# Long 4L80E Servo Pin

Don't Mix these Two

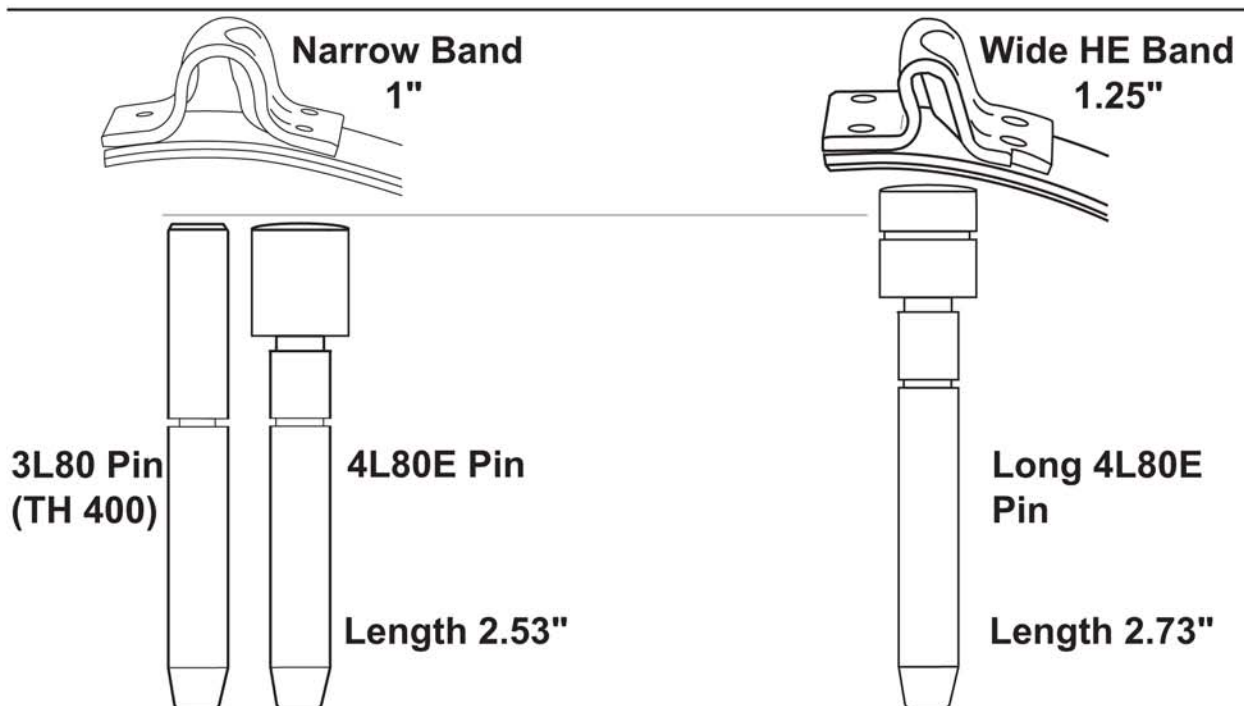
Wide Band with Short Pin or vice versa

1. The new 1.25 wide high energy band will retrofit back using the longer pin.
2. Do NOT use the two short pins with the wide band!
3. Make sure to match the correct pin with the band if you are replacing or changing the band.
4. Take careful notice of the two band anchors. The wide band anchor is squeezed together more and therefore requires a longer pin.
5. Pins can only be purchased as a kit (pin, piston, spring & seal):  
Long Pin Kit OE # 24223081 Short Pin Kit OE# 24200418
